City of Sealy Flood Early Warning System

Contract #1600012049

Texas Water Development Board Comments to Draft Report

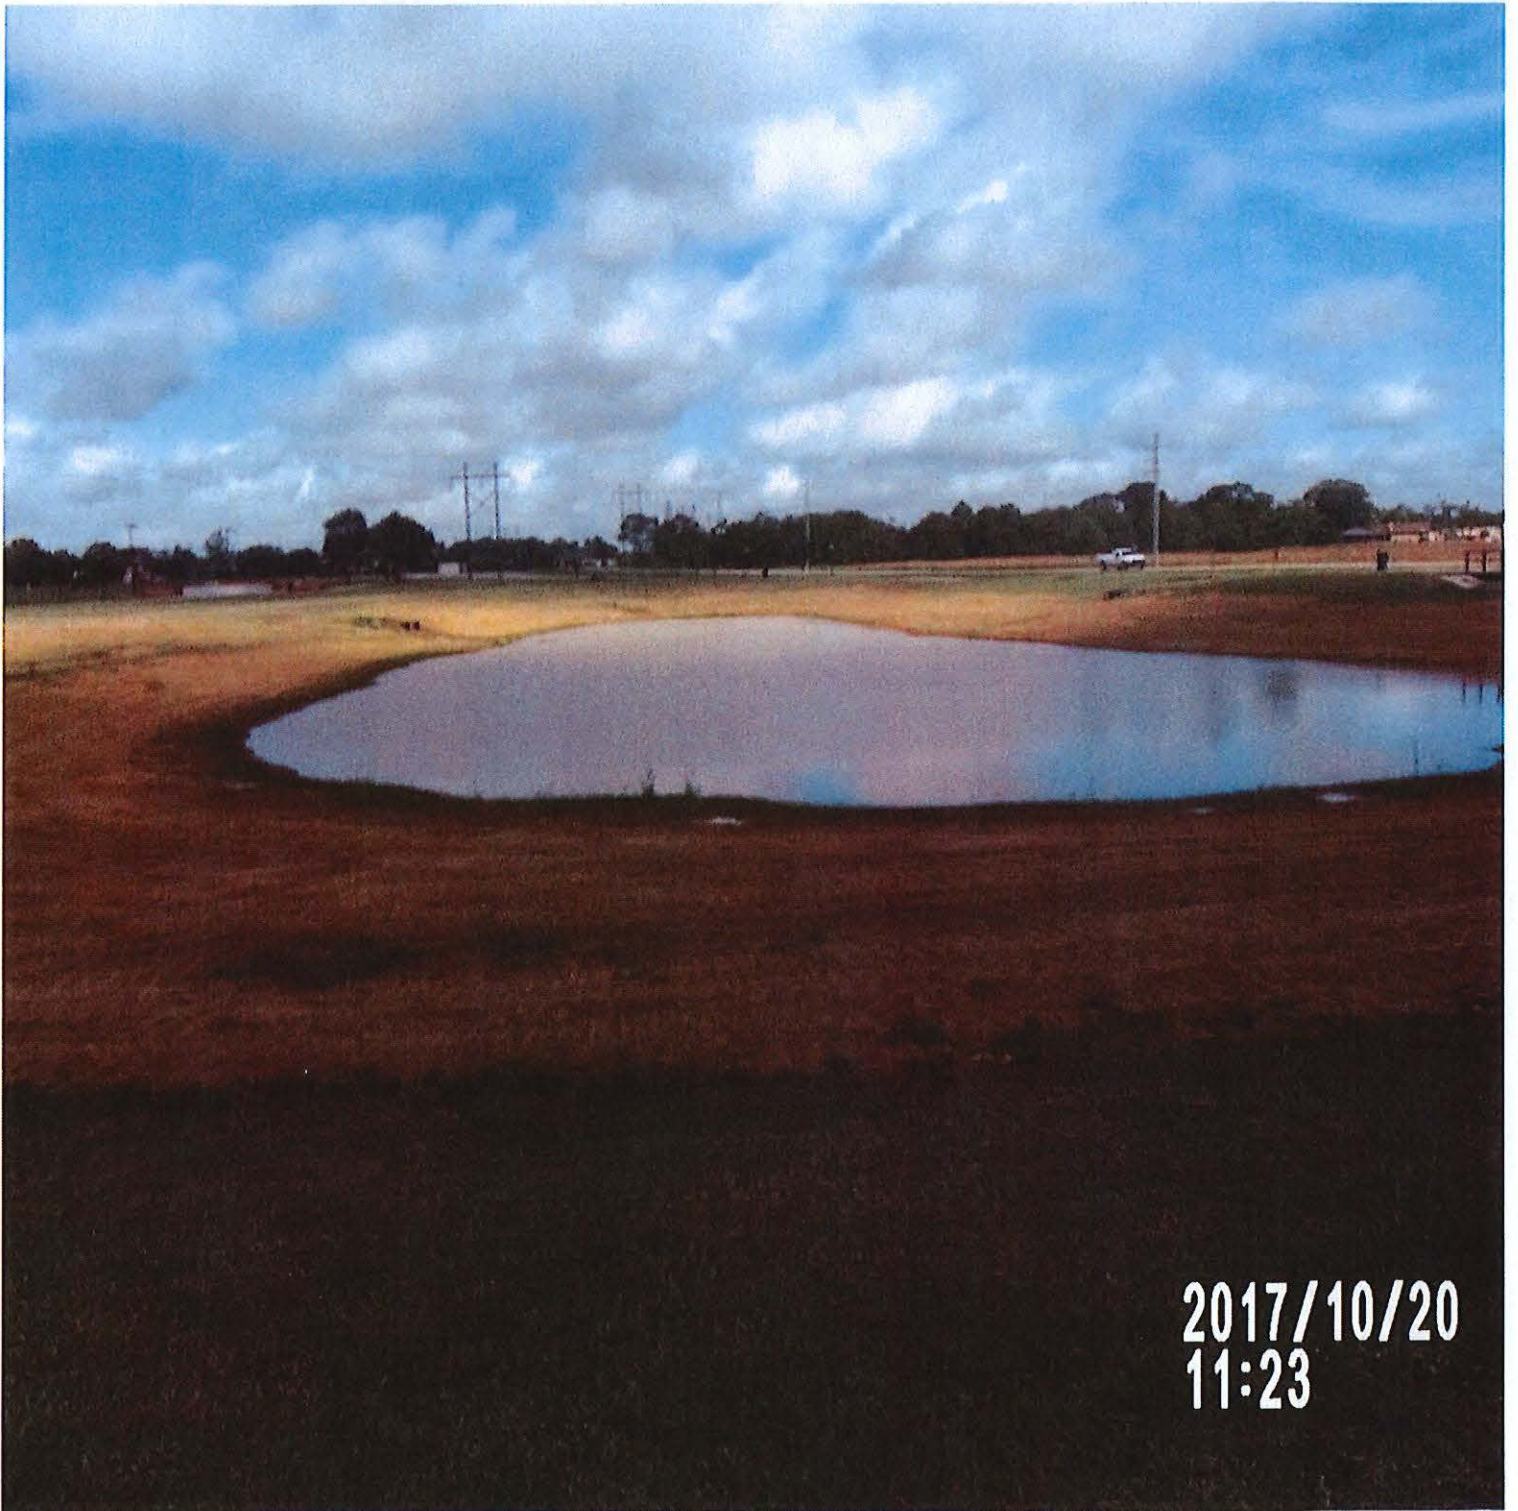
1. The draft report included photos of the pond, however, no indication of the phase of the project when they were taken in. Please label the photos as either pre, post, during excavation, or as appropriate.
2. The draft report indicates that a contracted drainage capacity report was completed which indicated a 14.5 acre foot capacity while the proposed capacity was 21.68 acre feet. Please, include a copy of the report or a brief discussion of the final capacity.
3. Please briefly discuss the "issues" that the City encountered when attempting to get the sensors to work with the City's "system".
4. The draft report consisted of a set of separate documents. Please submit the final report as one complete document.
